**Sent:** 2/05/2021 11:10:53 AM  
**Subject:** DA2021/0317 141 Riverview Rd Avalon  
**Attachments:** LETTER TO COUNCIL 2- GREG & BERNADETTE O'NEILL.docx;

**RE: DA 2021/0317 - 141 RIVERVIEW ROAD, AVALON BEACH  
SUBMISSION ON BEHALF OF NEIGHBOURS - 137 RIVERVIEW ROAD**

My wife and I am the owners of 137 Riverview Road, Avalon and together with input from a friend/architect we have reviewed drawings DA01 - DA17 and 3D artists impression all dated 22 March 2021 prepared by Fyffe Design, Statement of Environmental Effects (S.O.E.E.) dated 22 March 2021 prepared by Key Urban Planning together with the other supporting documents submitted to Council.

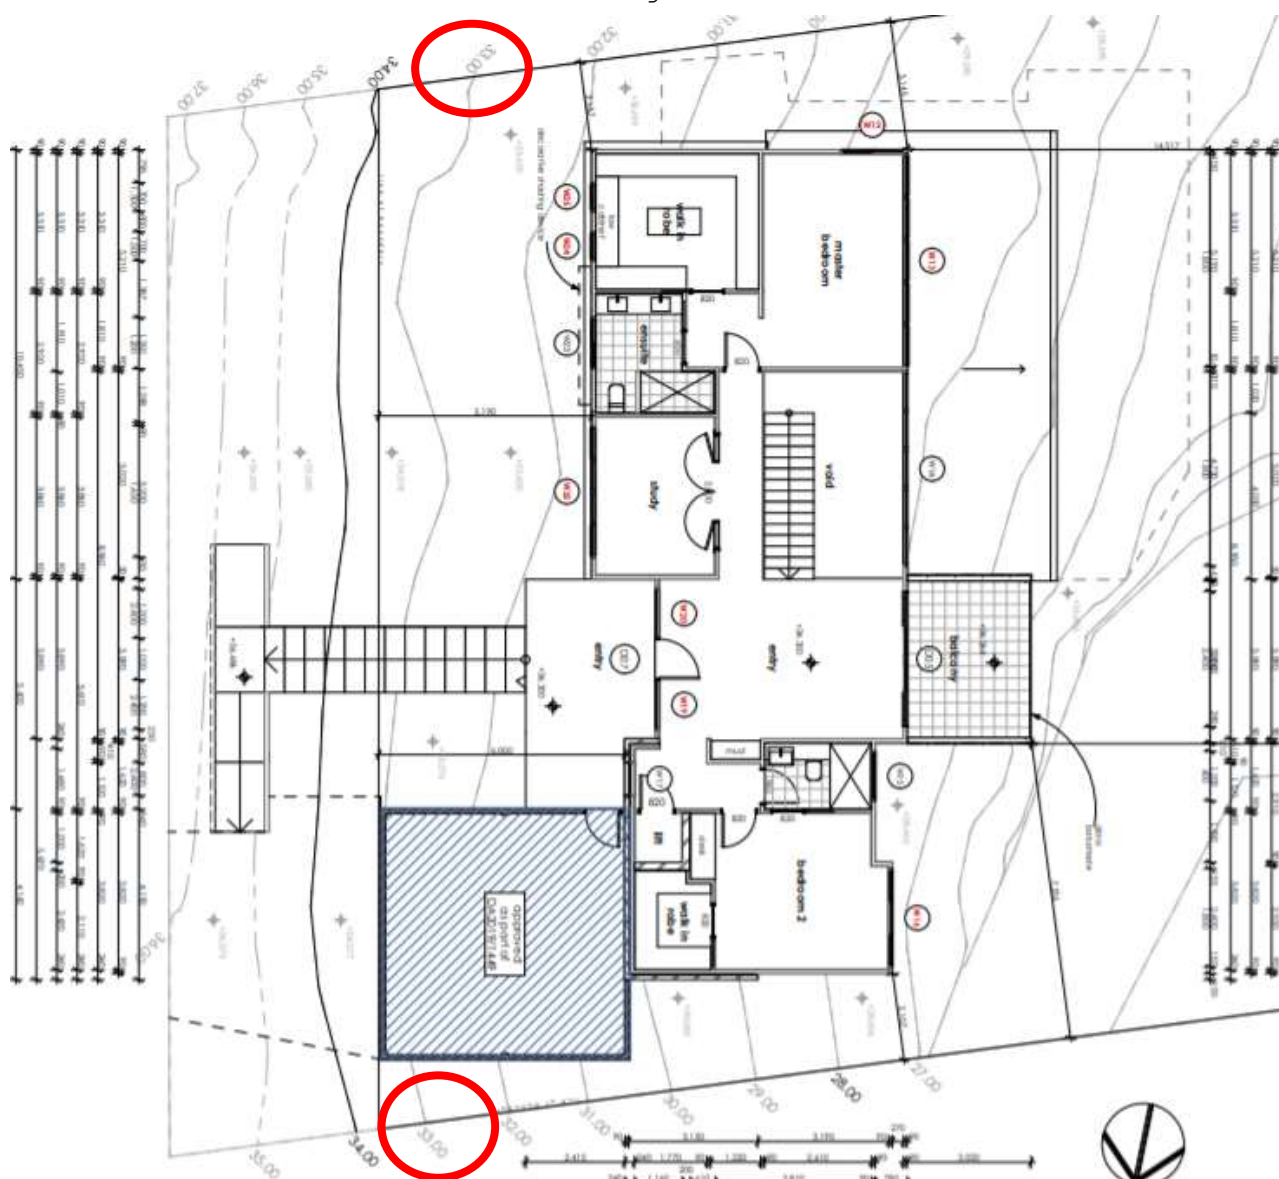
Architectural drawings DA04 - DA06 all show that the eastern most contour line within the site as being RL 33.00.

The survey prepared by D P Surveying appears to show that the eastern most contour line within the site is RL 34.00. (hand

Page 40 - Arborist Report.

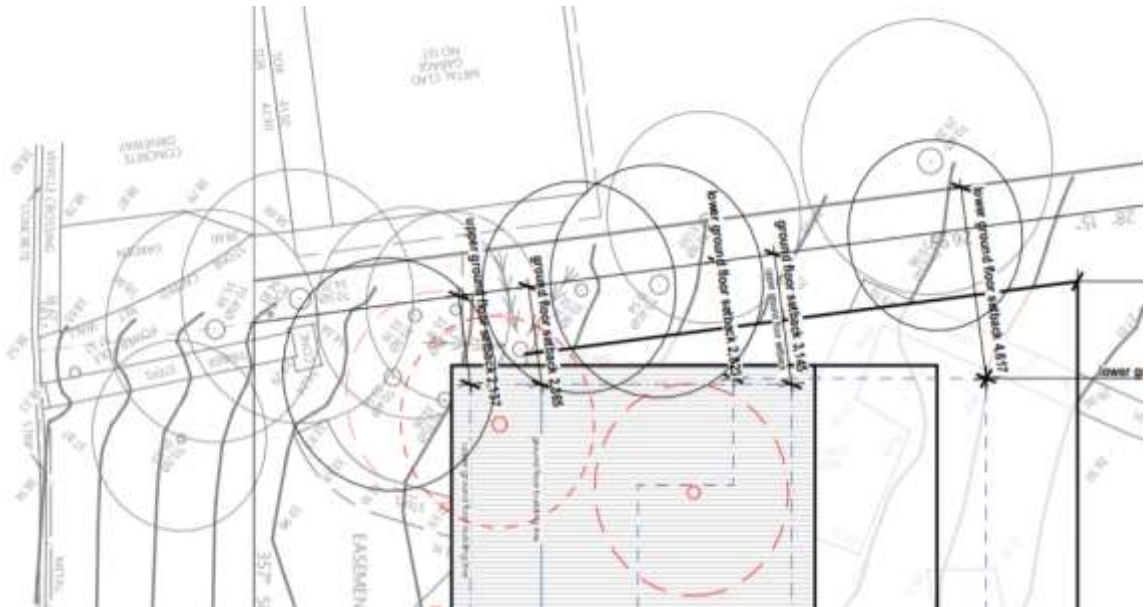
As noted in the following table, there are some differences between the trees requested and those recommended. Requested tree numbers 11 & 12 (located in Council's road easement) have not been recommended for removal, and tree 31 is noted as an exempt species, not requiring consent for removal. If tree 31, a *Pittosporum undulatum* is exempt, why are trees of the same species numbered 17 & 18 approved for removal?

Now included in the recommended consent approvals for removal are trees 26 and 33, which were not requested. Why are trees requested for retention now being recommended for removal?

Drawing DA03

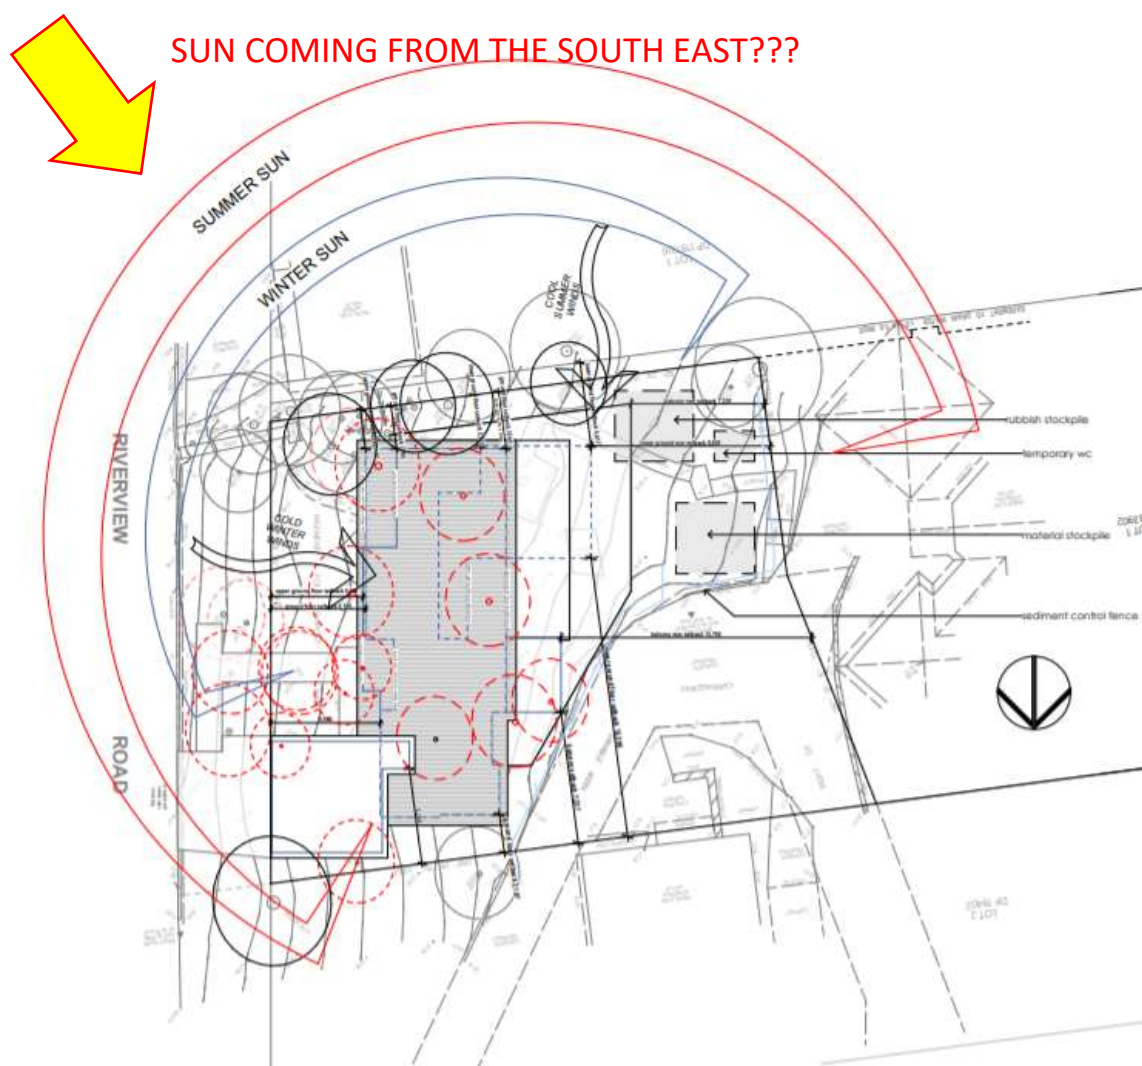
The difference in tree numbers stated above, together with drawing DA03 (below) show eight trees being retained to the south of the development yet omitting to show the Ground Floor southern balcony and access stairs depicted on drawing DA05 leads us to question exactly which trees are proposed to be removed. The statement in the S.O.E.E. "Further tree removal may be required to comply with the RFS 10:50 Code" also causes concern that this maybe used for additional tree removal.

It is requested that the applicant resubmit documentation to fully and accurately identify all trees proposed for removal.

Drawing DA02

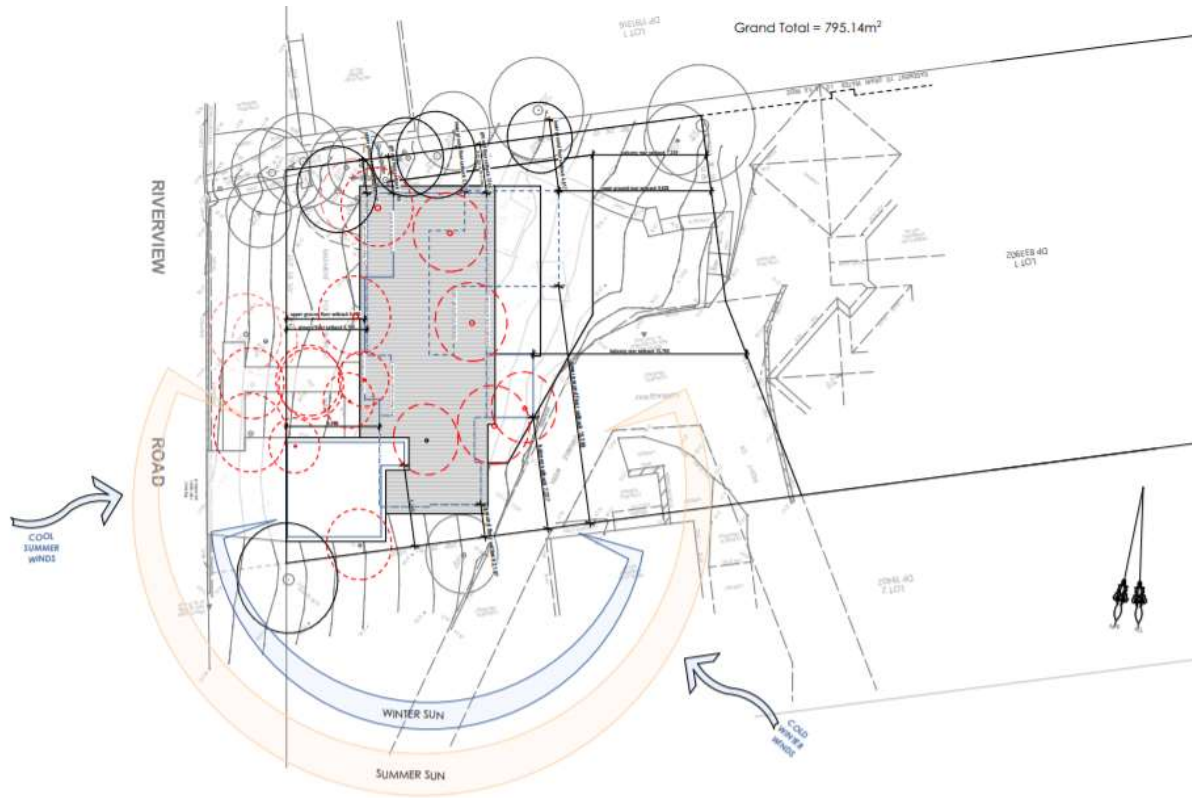
The validity of solar access documentation contained in the application is further put in doubt with drawing DA02 showing the Sun coming from the South East as opposed to drawing DA03 correctly showing the Sun coming from the North.
